Intel[®] 460GX Chipset

Specification Update

January 2002

Document Number: 249731-002

Figure 1. Recommended Workaround for Erratum 1

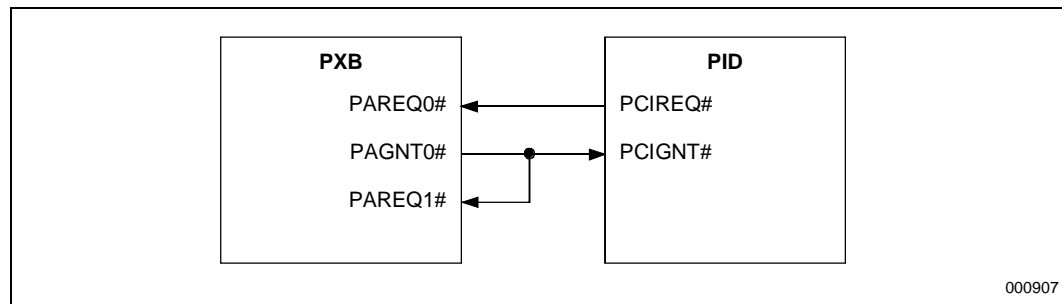
1. PID stops responding under certain conditions when PCI bus is parked on it

Problem: It is possible for the PID to stop responding when the following conditions are met:

- The PCI bus is parked on the PID, and thus its GNT# signal is asserted.
- The PID has an inbound SAPIC message it is about to send.
- The PID's GNT# signal is deasserted.

In this case it is possible that upon the assertion of the PID's GNT# signal, the PID will stop responding to any interrupt requests or PCI bus transactions targeting it.

Implication: If the PID stops responding, any interrupt requests routed to this PID will no longer be serviced and the system may hang.

Workaround: The workaround is to prevent the PCI bus from getting parked on the PID. With the PXB, it is accomplished by connecting the PID's PCI GNT# pin to an unused PCI REQ# input on the PXB that has the PID attached to it. See [Figure 1](#).

If no unused REQ# input is available on the PXB, the PID's PCI GNT# signal can be ANDed with another REQ# input.

This workaround results in the PXB always seeing a REQ# being asserted when the PID has been granted the bus, thus keeping the PCI bus from being parked on the PID. When the PID's GNT# signal is deasserted by the PXB, the REQ# line tied to it is also deasserted. If there are not any other outstanding requests for the PCI bus, the bus will be parked on the PXB since the REQ# signal and PID's GNT# signal get deasserted in the same clock.

For systems which use the PID, but not a PXB, a similar workaround will have to be implemented using the REQ# and GNT# pins to again ensure that the PCI arbiter does not allow the PCI bus to be parked on the PID.
